Wollongong Local Planning Panel Assessment Report | 13 June 2023

WLPP No.	Item No. 1
DA No.	DA-2022/1023
Proposal	Residential - demolition works, tree removal, construction of 12 units and 20 townhouses with associated basement car parking, landscaping and services infrastructure
Property	15 Nicholson Road, Woonona; Lot 101 DP 1279511
Applicant	Martin Morris & Jones Pty Ltd
Responsible Team	Development Assessment and Certification - City Wide Team (VL)
Lodgement date	26 September 2022
Prior WLPP meeting	N/A

ASSESSMENT REPORT AND RECOMMENDATION

5 Landscape ADG
1:500

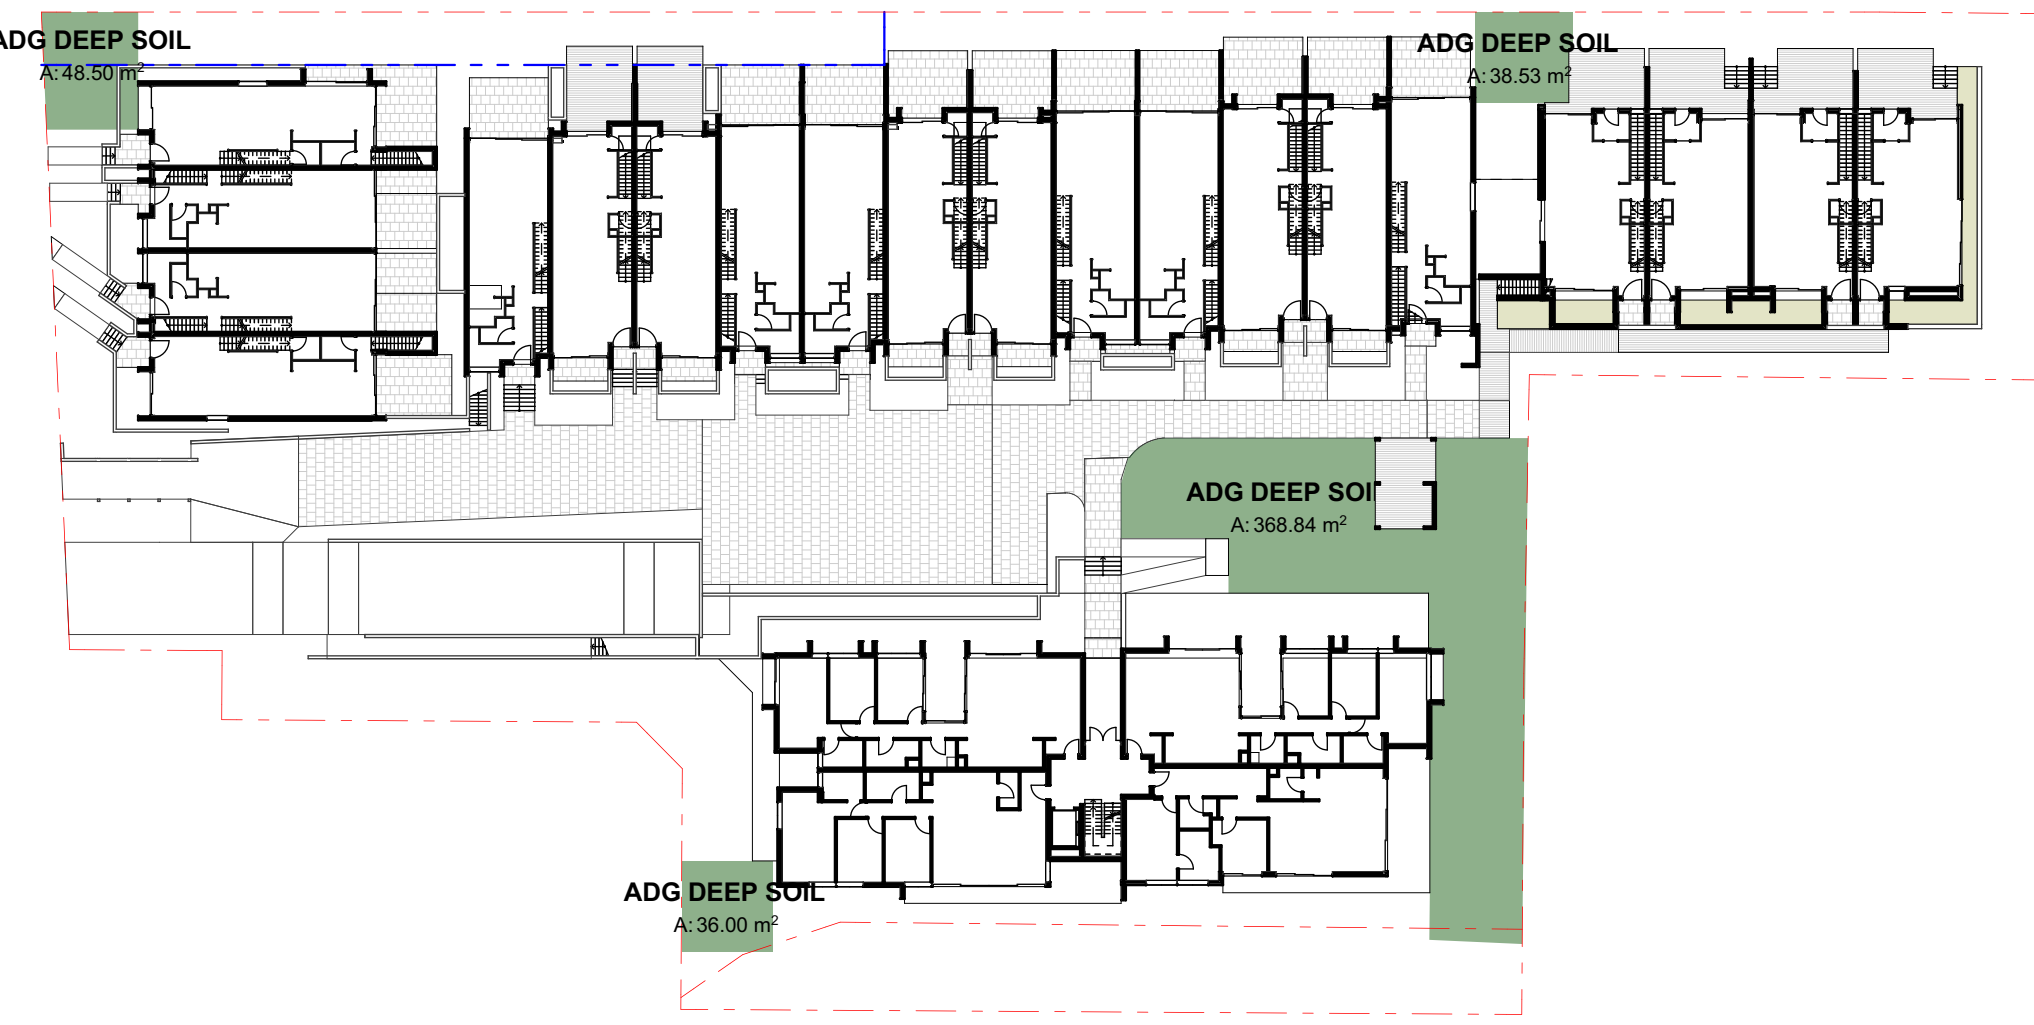
The proposed gross floor area indicated on the submitted gross floor area plans excludes certain areas within the buildings which are included in the definition of gross floor area (GFA) provided by the Dictionary in WLEP 2009.

There appears to be multiple sections throughout the development of lower level areas which have been excluded from GFA on the basis that they are basement but which floor levels immediately above that are more than 1m above existing ground level. Limited cross sections have been provided to detail the relationship between the proposed development and existing ground levels, noting significant excavation is proposed to accommodate the built form. However, it has been identified along the north, south and eastern façade of the residential flat building and the eastern elevation of Building C that the floor above the “basement” will exceed 1m above existing ground level. Situated in these areas are storage areas for the units and vehicle access. As they do not meet the definition of a ‘basement’ in WLEP 2009, these areas should be included in the GFA calculations.

As discussed in section 2.25 above under Clause 4.4 of WLEP 2009, the applicant identifies the FSR as compliant however, it is considered based on the plans submitted the FSR for the proposal will exceed the maximum of 0.75:1. No written request pursuant to Clause 4.6 has been provided.
